PRELIMINARY  
DA IMPACT REPORT

UTS Blackfriars Precinct  
Blackfriars Precinct Research Building

**To the Department of Environment and Planning**

The University Notre Dame Australia Sydney

## Shadow Diagrams

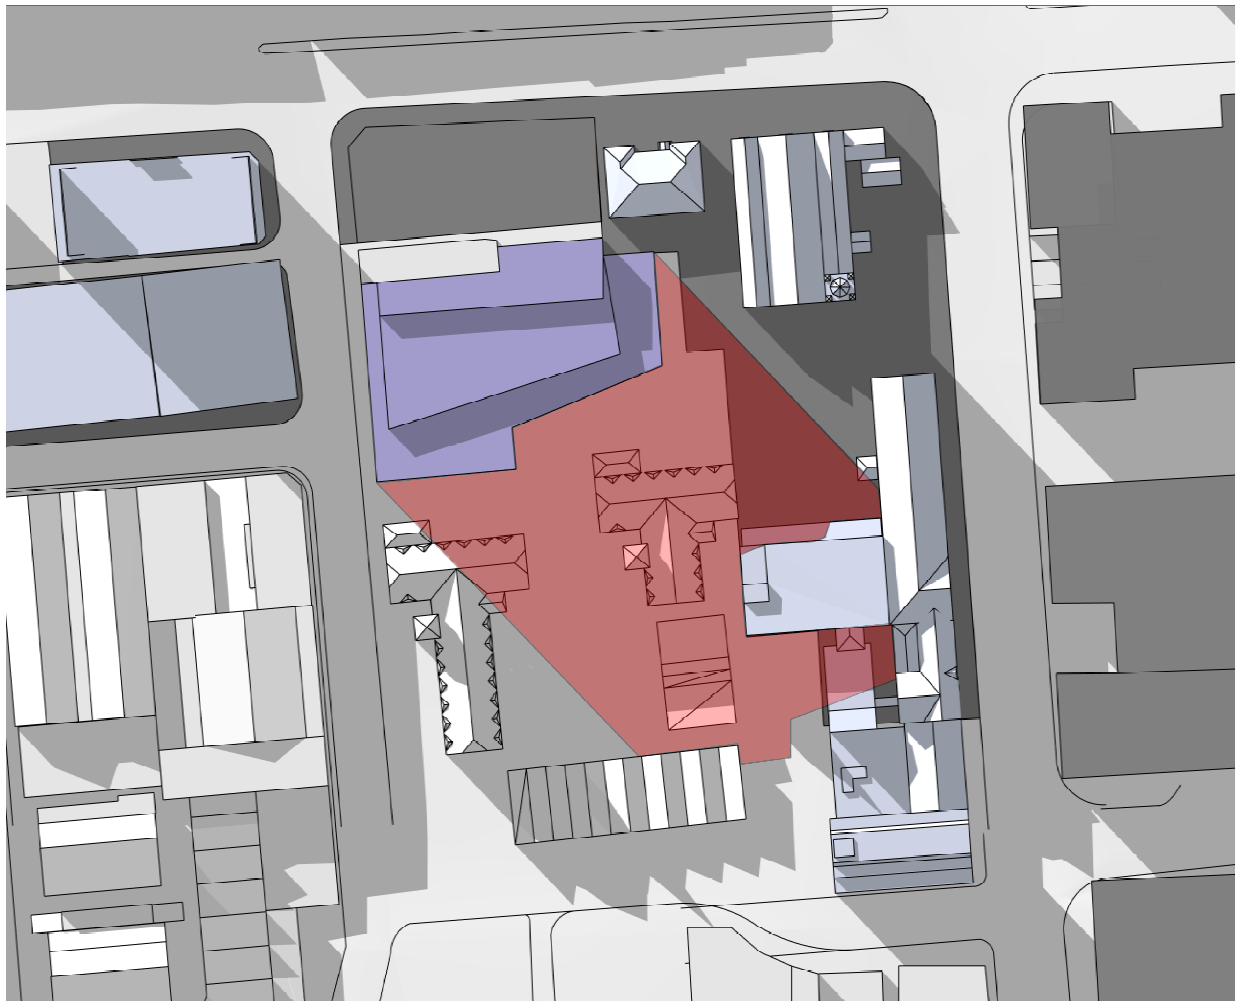
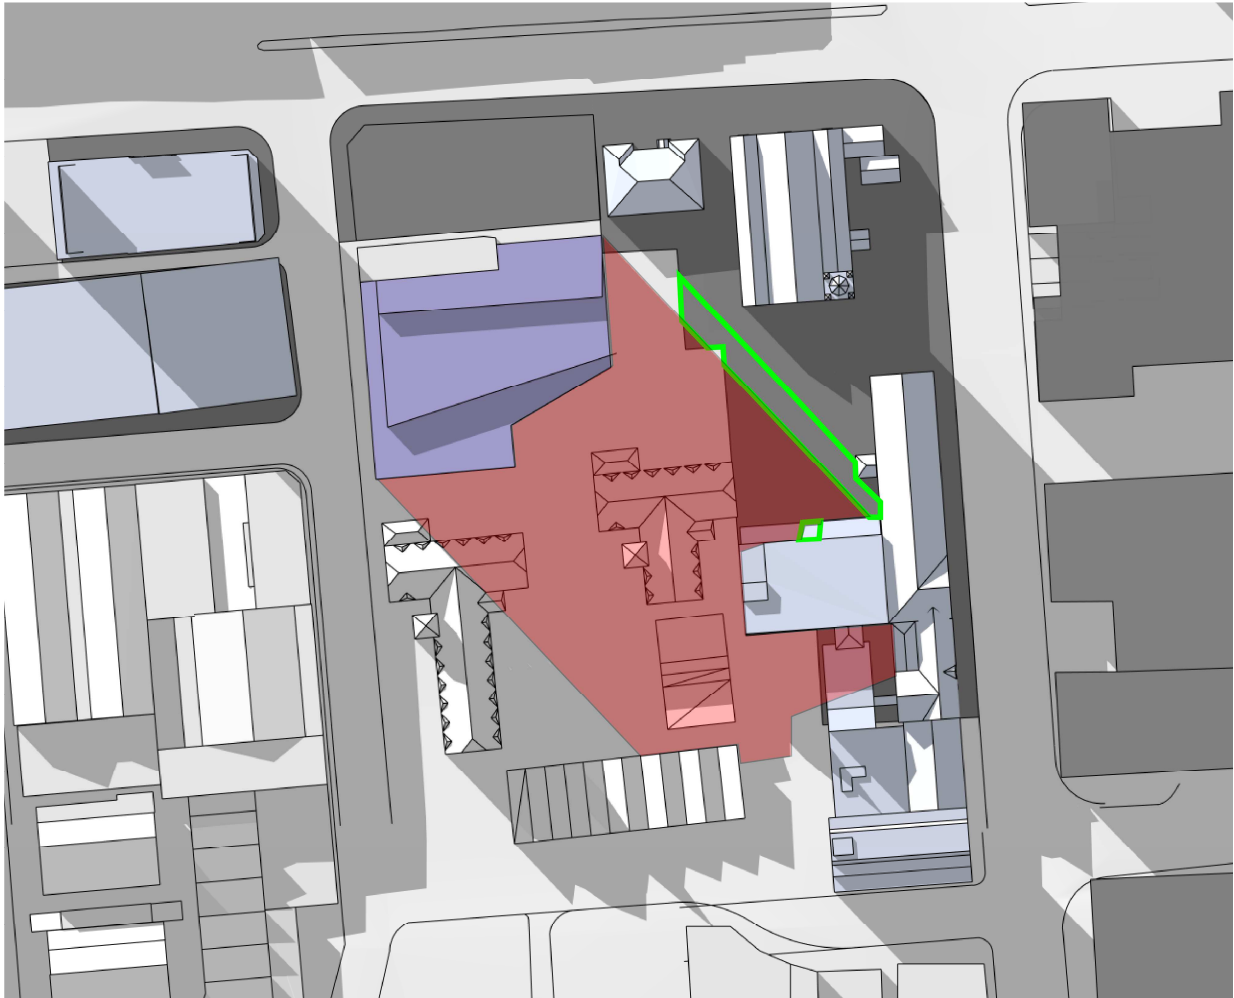
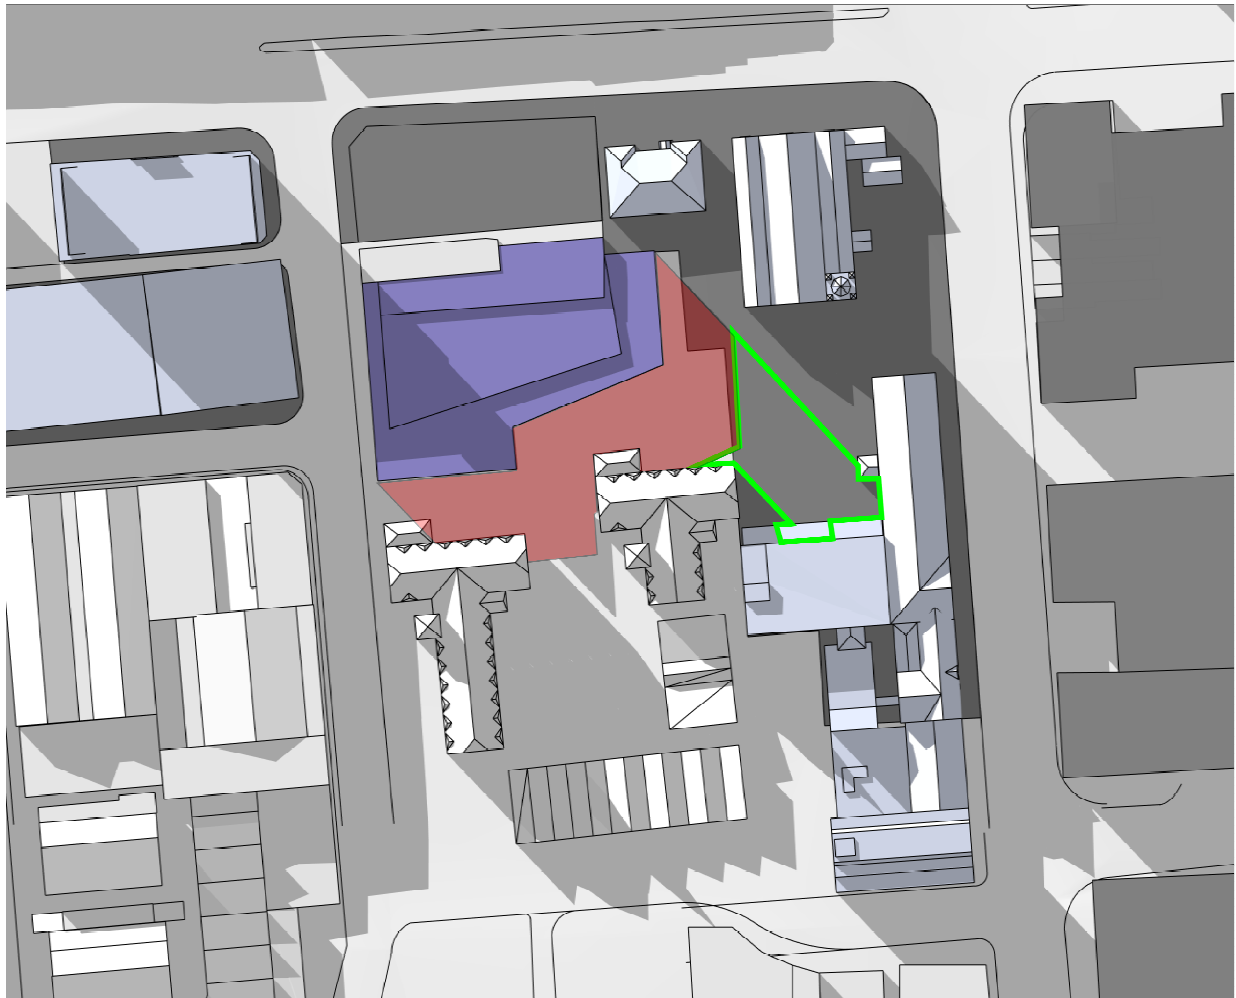
The increased FSR and height of the building results the potential increased overshadowing. This impact is likely to be reduced when the proposed envelope is setback from the western boundary of the St Benedict's Campus and / or when the proposal is reduced in height.

Refer to the diagrams included in appendix A. The diagrams indicate that the impact of overshadowing on the St Benedict's Courtyard is significantly reduced by lowering the building to within the permissible 9 metre height limit.

The reduction in shadow outlined in green.

The proposed envelope with setback 3 pm June 21<sup>st</sup>

The proposed envelope with reduced height 3 pm June 21<sup>st</sup>
